LEXINGTON-FAYETTE URBAN COUNTY GOVERNMENT CONTRACT CHANGE ORDER Page 1 of 2	Date:	April 8, 2016
	Project:	Fire Station #2 Replacement
	Location:	Lexington
To (Contractor): Olympic Construction, LLC 216 Bromme Drive Nicholasville, KY 40356	Contract No.	013-2016
	Original Contract Amt.	\$4,618,900.00
	Cumulative Amount of Previous Change Orders	\$0.00
	Percent Change - Previous Change Orders	0.00%
	Total Contract Amount Prior to this Change Order	\$4,618,900.00
	Change Order No.	1

PROJECT: Fire Station #2 Replacement

CHANGE ORDER NO. 1

Work Changes Proposal Request No. 1 Revised

Attachments: C-102, C-201

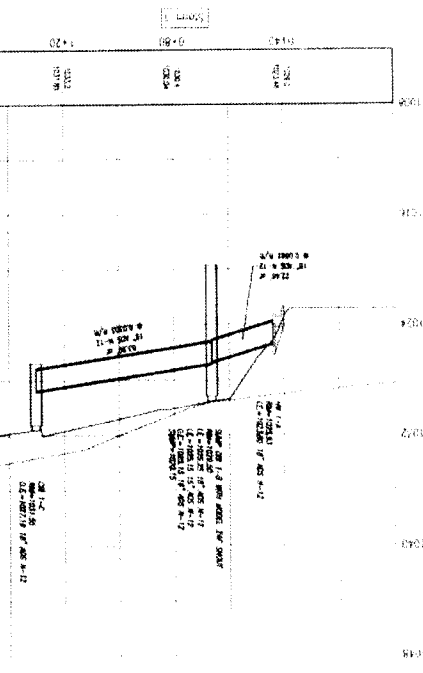
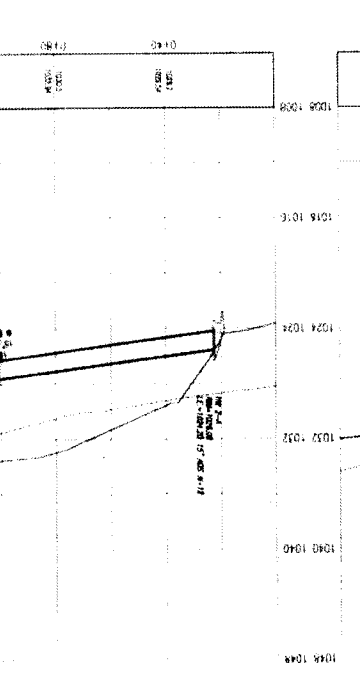
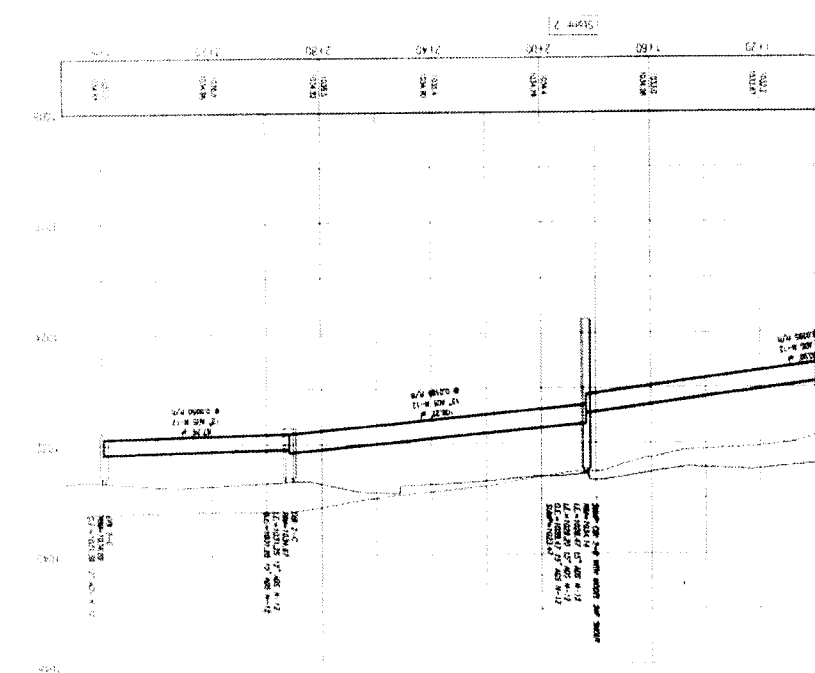
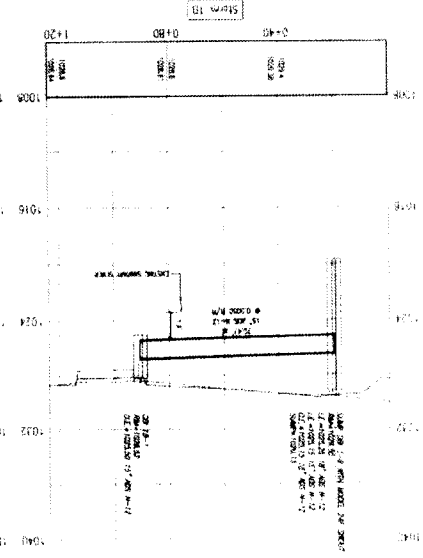
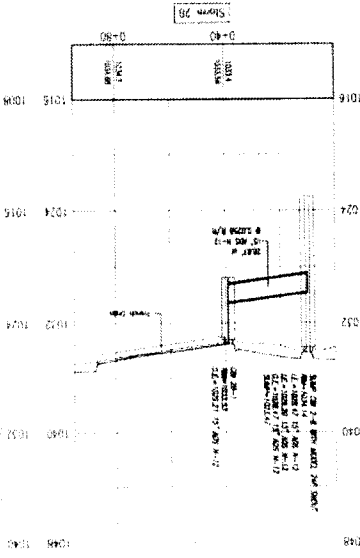
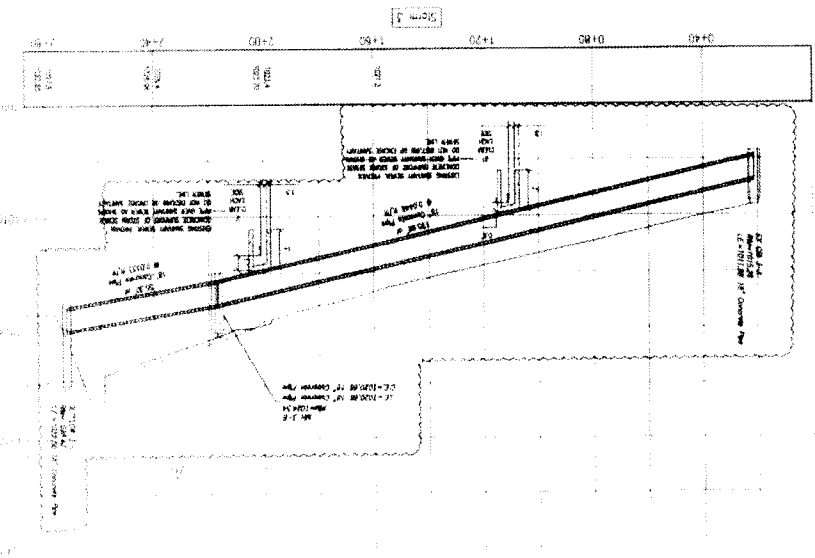
1. Per the City review and inability to gain an easement from adjacent property owner, Provide itemized pricing to modify storm sewer as shown in the attached updated sheets C-102 Grading and Drainage Plan and C-201 Profiles.
2. Per contractor request in RFI 2, please submit credit pricing to use the following piping for sanitary piping below slab and on the exterior for City to review for consideration.
 - SDR 11 piping in lieu of heavy duty cast iron piping for all exterior sanitary sewer piping
 - Schedule 40 PVC piping in lieu of Cast Iron piping below slab.
3. Per City request, please submit itemized pricing to add CMU base course(s) to Patio Footing on East side to bring even with patio slab and adjacent grade as discussed at the Progress Meeting on 3/31/16.

Modification per the PR1 Item One

1) Excavator with operator 3hrs x \$205.00	\$615.00
2) Labor 3hrs x \$46.00	\$138.00
3) Extra Materials needed	\$482.00
